## ARCHITECT'S ADDENDUM

Addendum Number: 006

**RE:** KANE COUNTY - Multi-Use facility

Subject: Addendum No. 006 to the Construction Documents for the Kane County Multi-Use Facility.

4 NORTH ELEVATION (REFER TO PRECAST PANEL ELEVATION ON 5/A5.11)  
 1/16" = 1'-0"

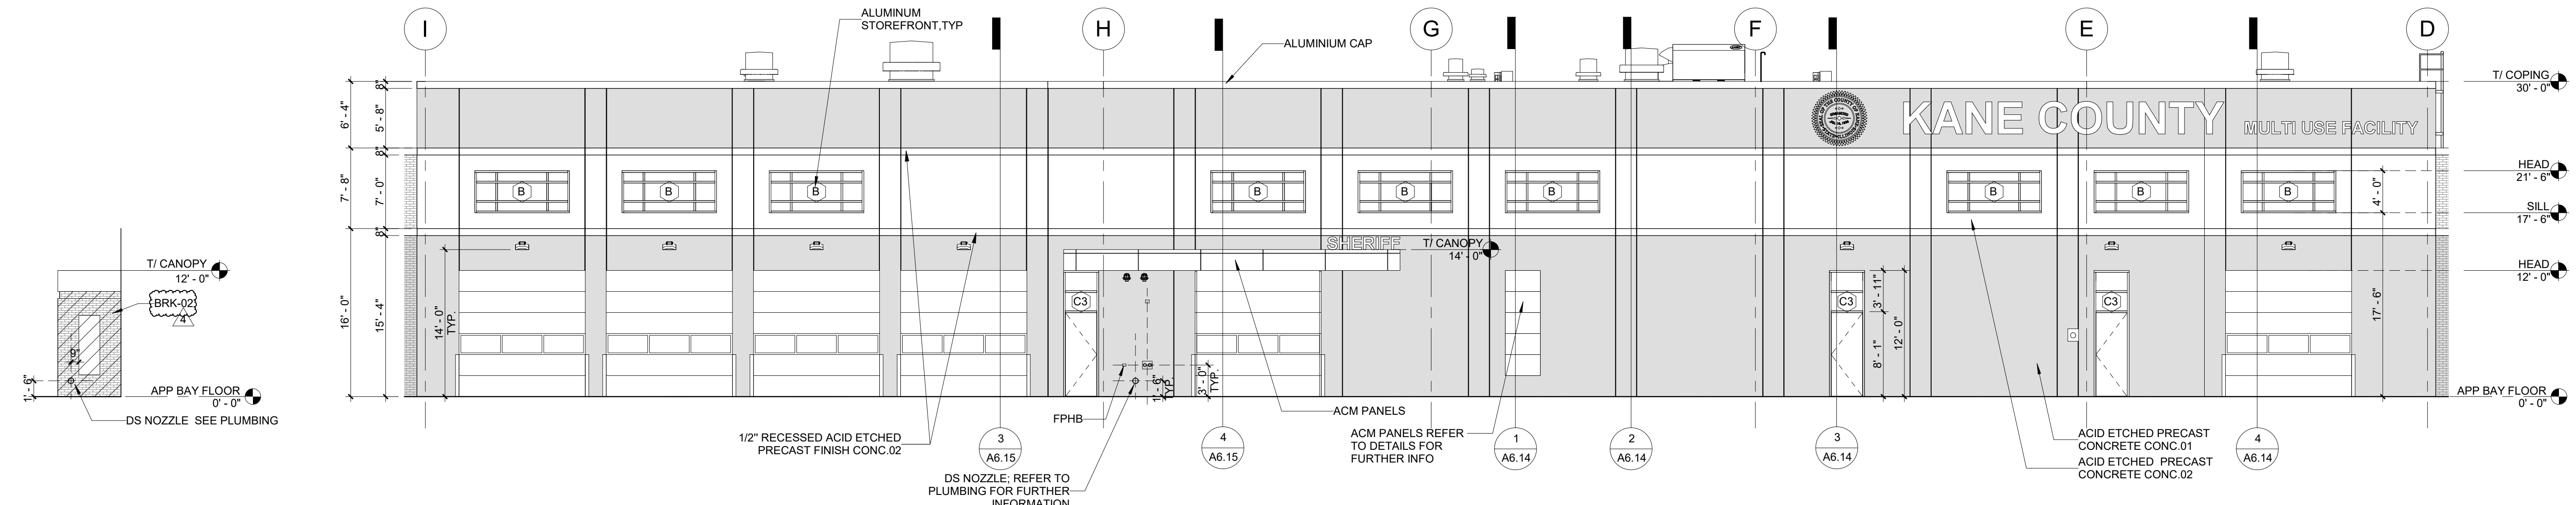
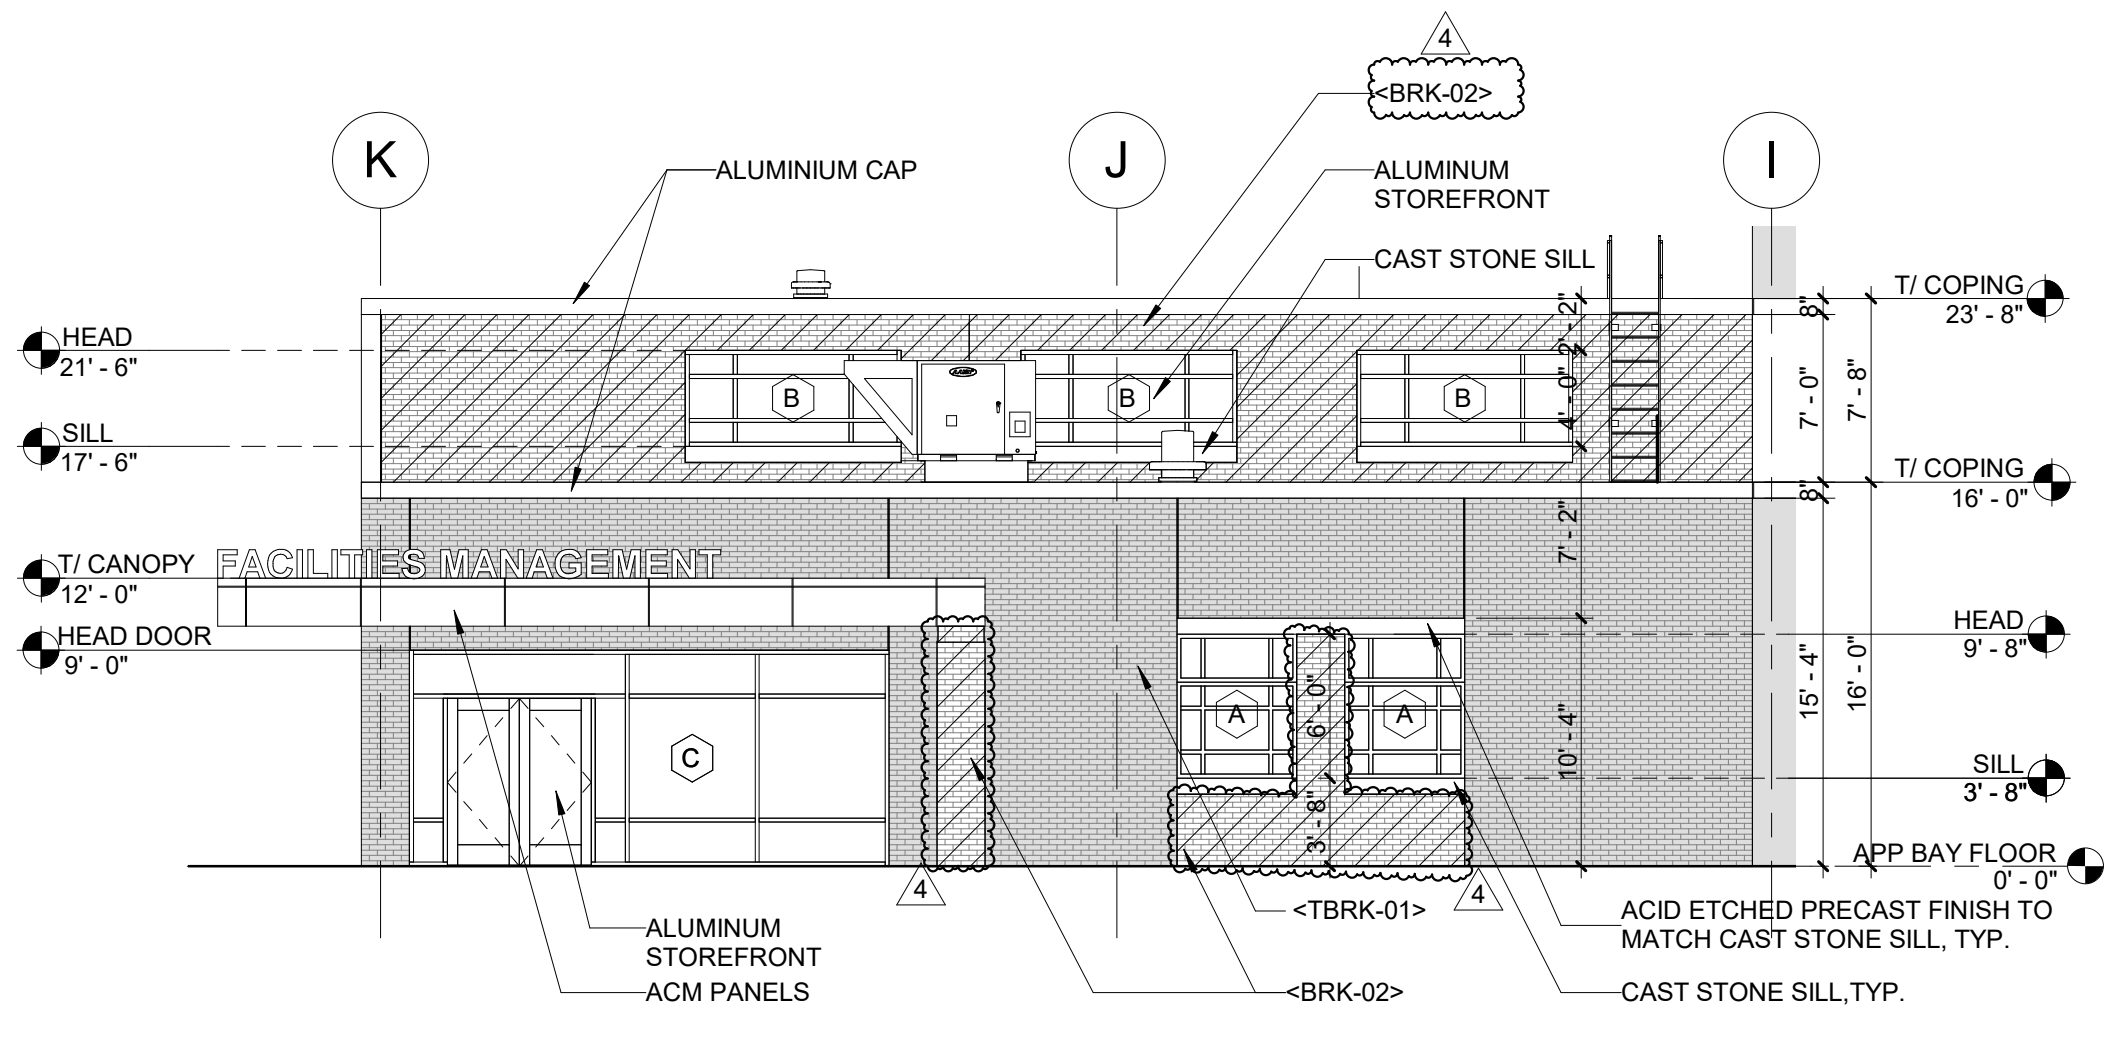
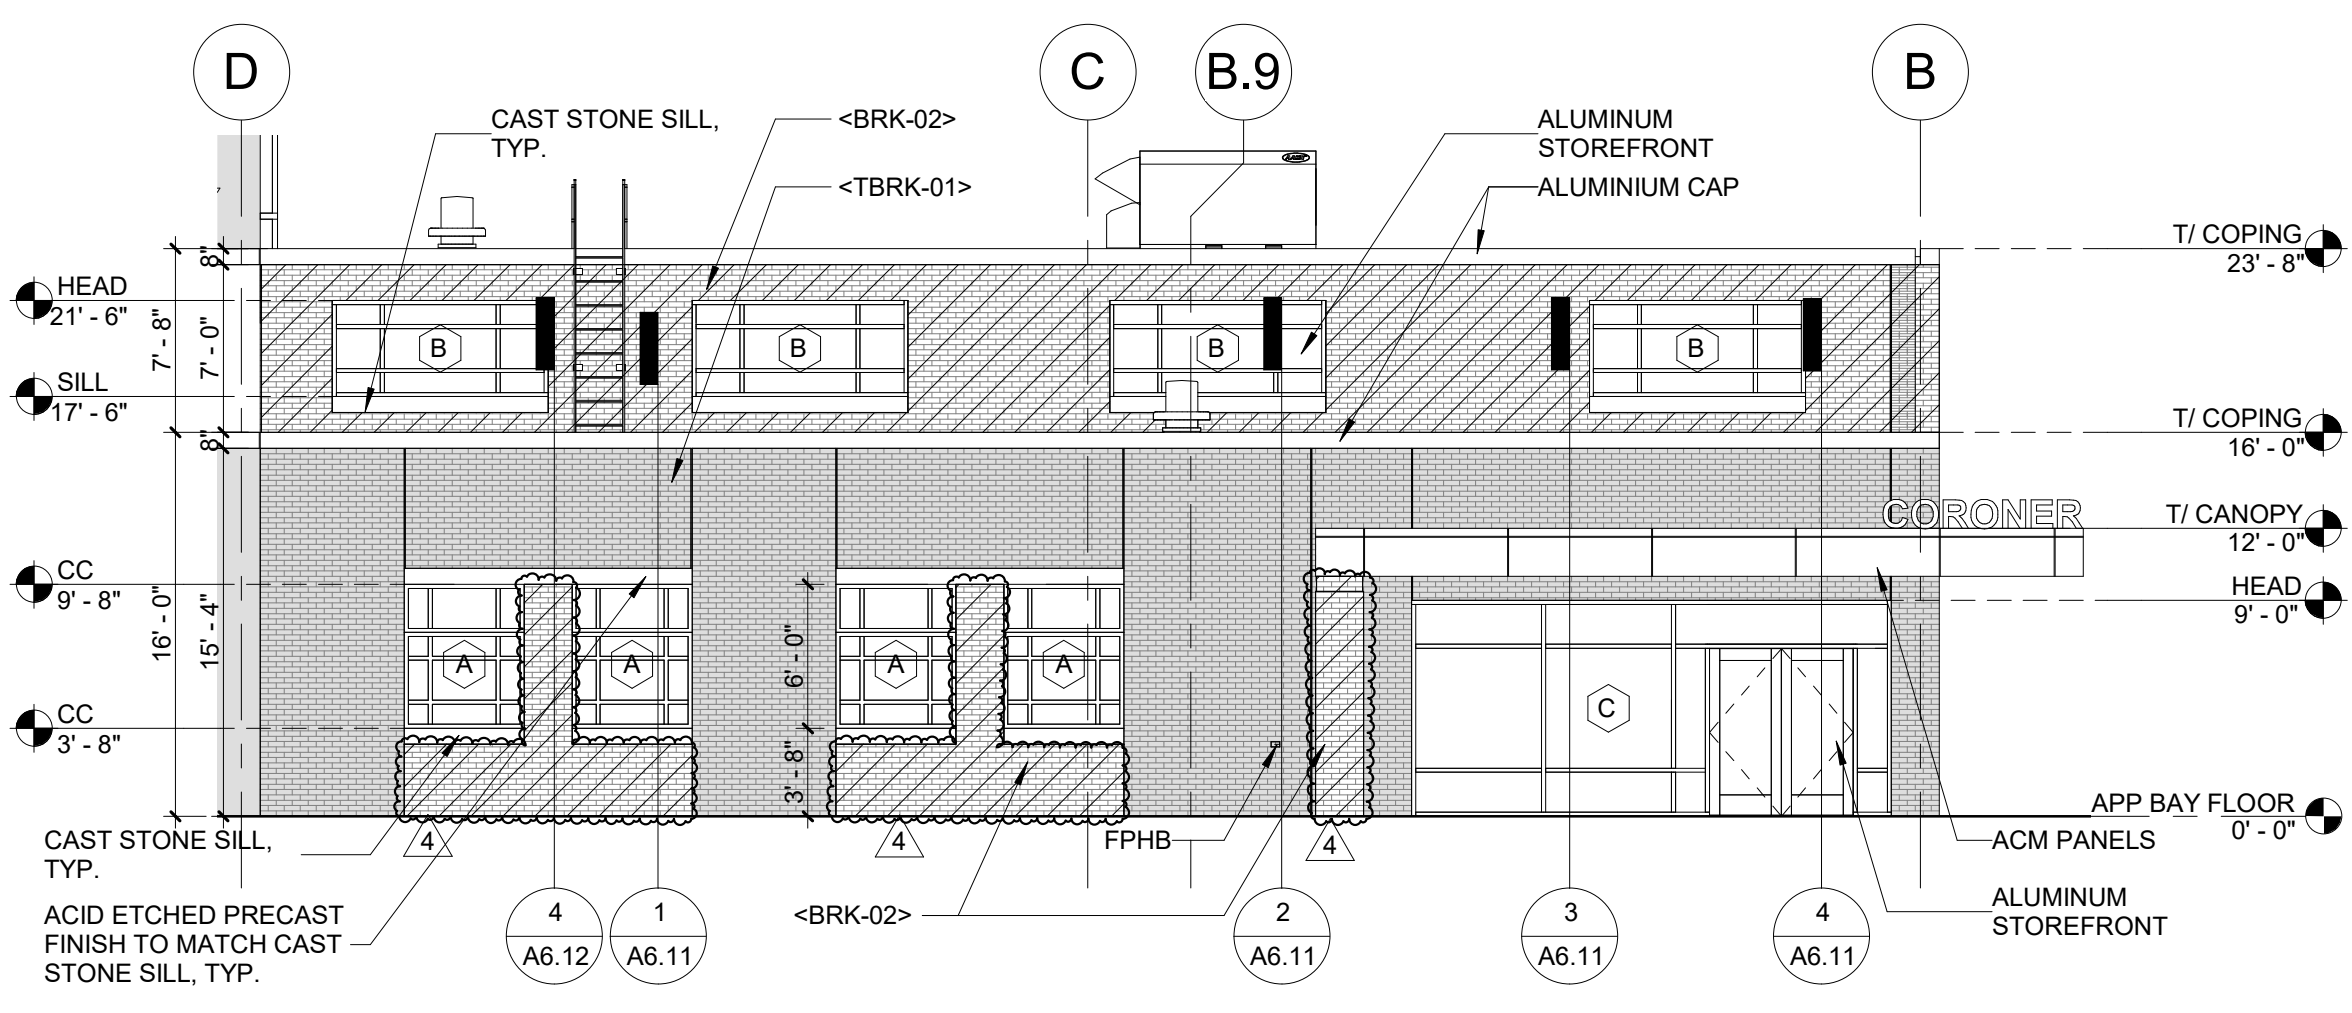
167	Lombard Architectural Precast Products, Co.	RFI #146 states the thinbrick mortar joints are to match TBRK-02(Georgetown), what about the joints at TBRK-01(Valley Forge)? Are we to match TBRK-01 also where this brick is indicated?	A5.1 and A5.3 - revised and included herewith		01.14.20	Arch	01.14.20	The mortar / precast color should match TBRK-02. The intent is to have one precast color throughout. Provide acid etched texture throughout. Achieve dark color (to match TBRK-01) via precast concrete stain. Refer to revised Exterior Finish Legend on A5.1 and A5.3 - attached herewith

1 WEST ELEVATION (REFER TO PRECAST PANEL ELEVATION ON 1 & 3/A5.14)  
 1/8" = 1'-0"

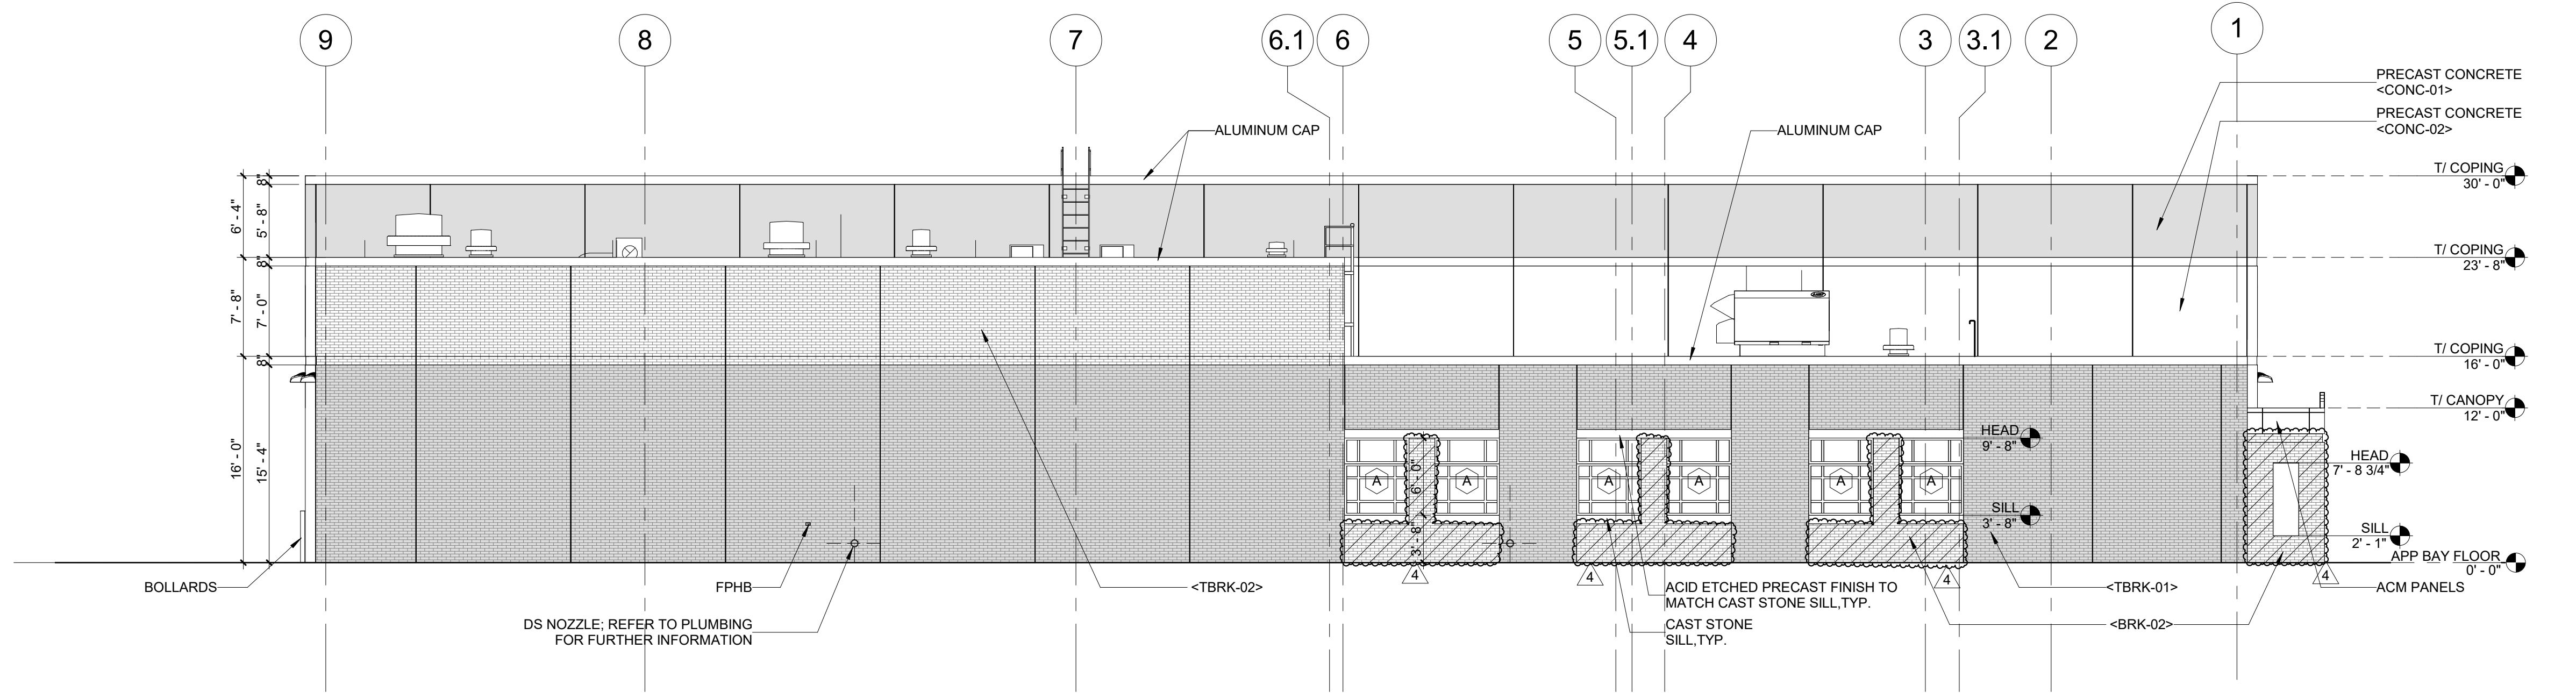
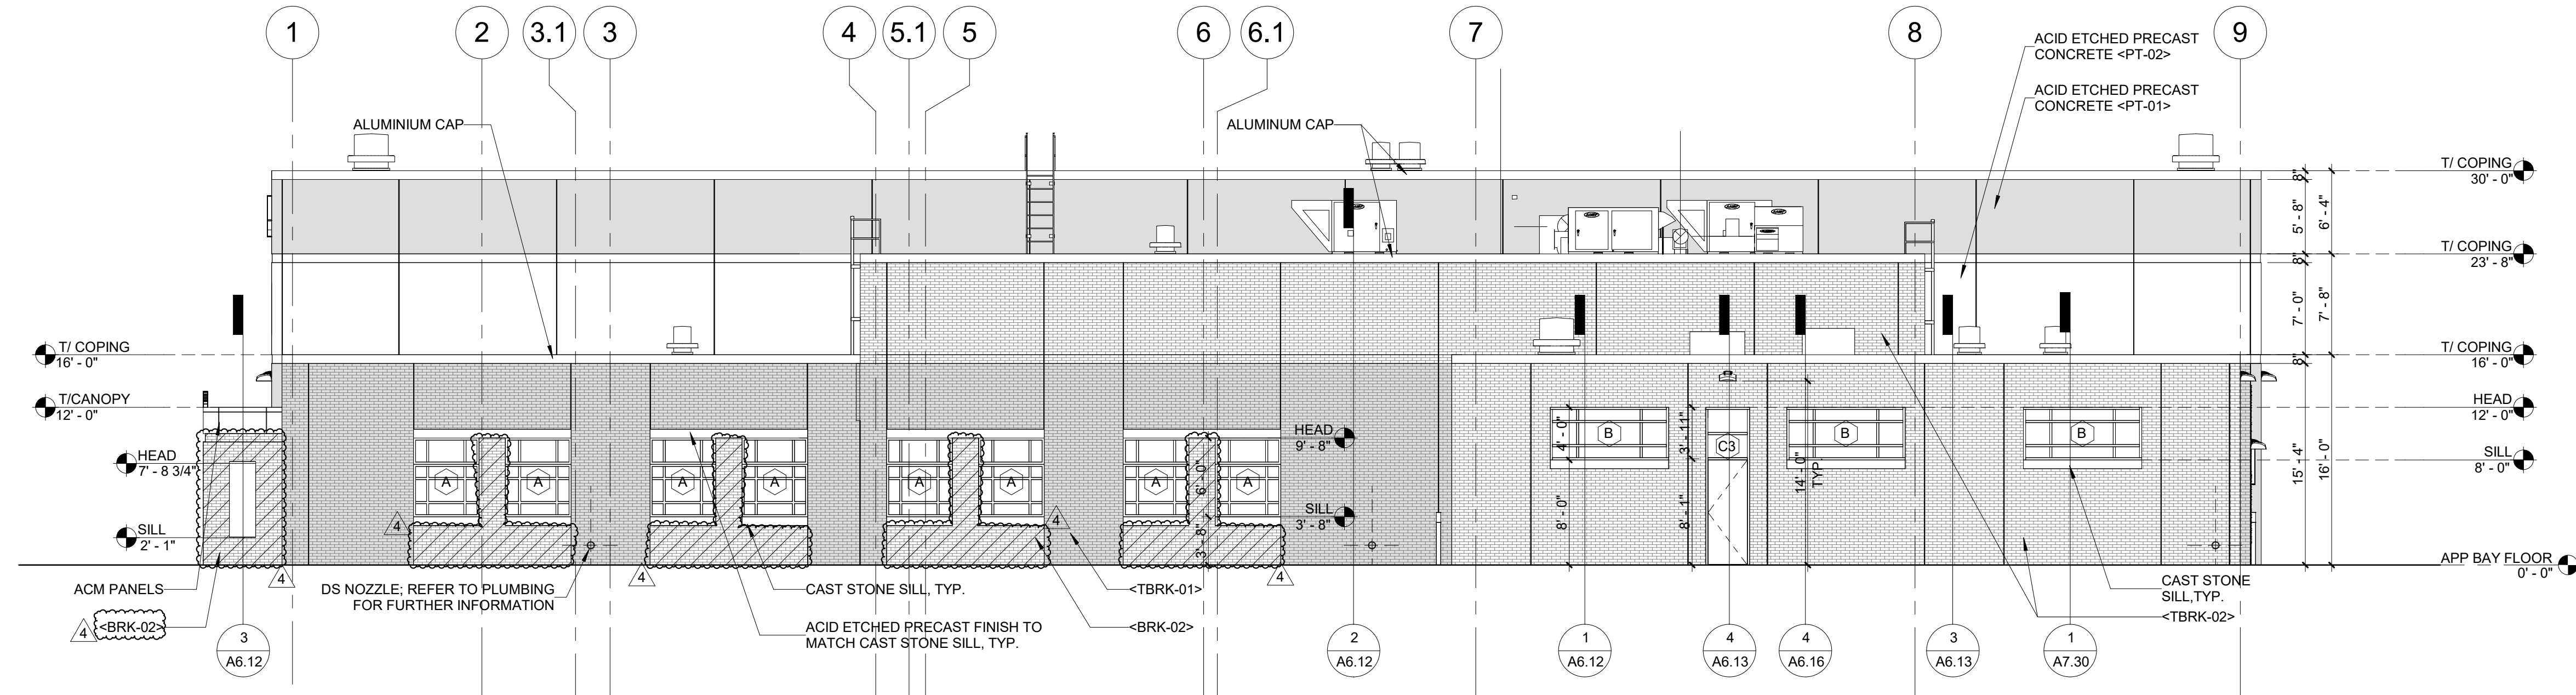
163		<p>18). The foundation insulation requirement is different from the architectural drawings and the structural drawings, which are we to use?</p> <p>19). Details 1,2,5,7/A7.3 indicate steel guards, what are they?</p> <p>20). What is the thickness of the stainless steel indicated in details 2,3/A7.27</p> <p>21). Detail 4/A7.3 and sheet C5.0 have different details for bollards, which are we to use?</p>	S3.1 and S3.2 - revised and included herewith		01.10.20	Arch / Structure	01.14.20	<p>18). Refer to revised S3.1 and S3.2 included herewith.</p> <p>19). Steel guards at locations indicated in referenced details shall be 4" x 4" x 1/4" painted steel angle 5'-0", mounted at 12" AFF.</p> <p>20). Same gauge as stainless steel cabinets</p> <p>21). Follow detail on 4/A7.3 and 3/S3.2</p>
164	George Sollitt Construction Company	West elevation detail 1/A5.3 shows three (3) type B windows between column lines 7-9 at the Sally Port On sheet A2.1A the floor plan for this area does not indicate any type B windows. Please advise if there are window on the west elevation of the Sally Port C138.	A5.3 - revised and included herewith		01.13.20	Arch	01.14.20	There will be three (3) windows on west elevation as shown on 1/A5.3.
